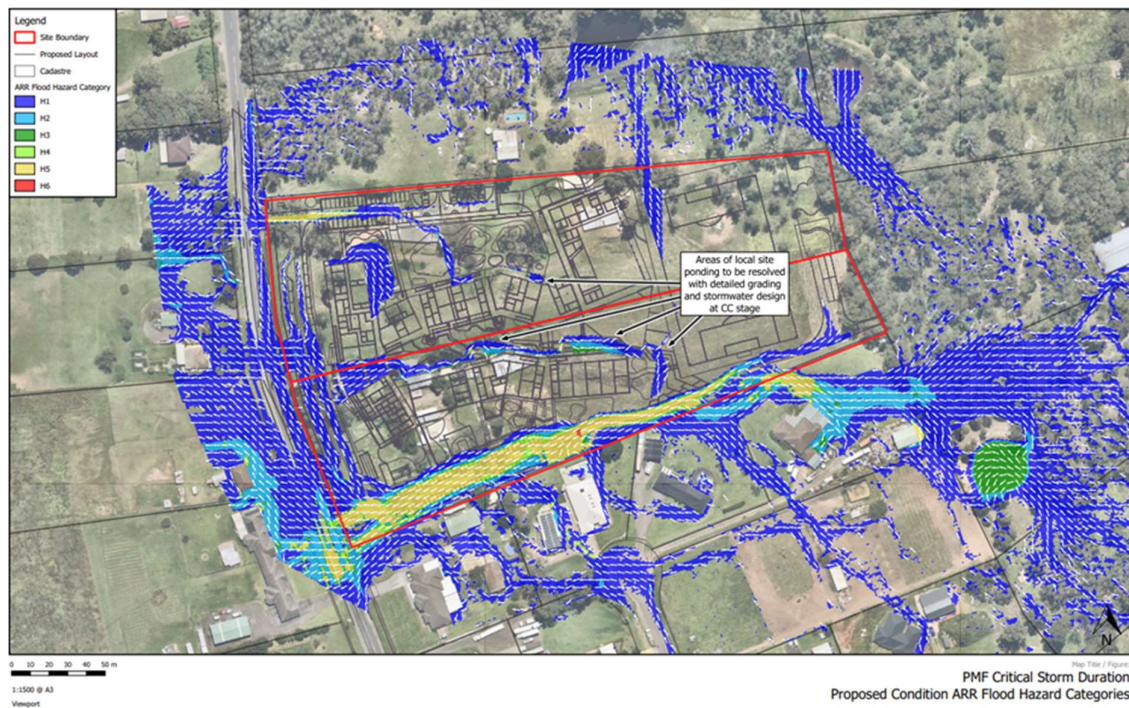
The site is not suitable for development at this point in time. The necessary infrastructure will not be in place to handle a development of this size and impact.

The Department has not identified Catherine Fields as being a priority within the South West Growth Area. Until a point of time that this occurs, no significant development should occur in the area. Council's previous comments summarise this issue succinctly:

"The Site is an unsewered rural property located on a rural road with no shoulder, formed kerb and gutter, footpath, lighting or piped underground stormwater"
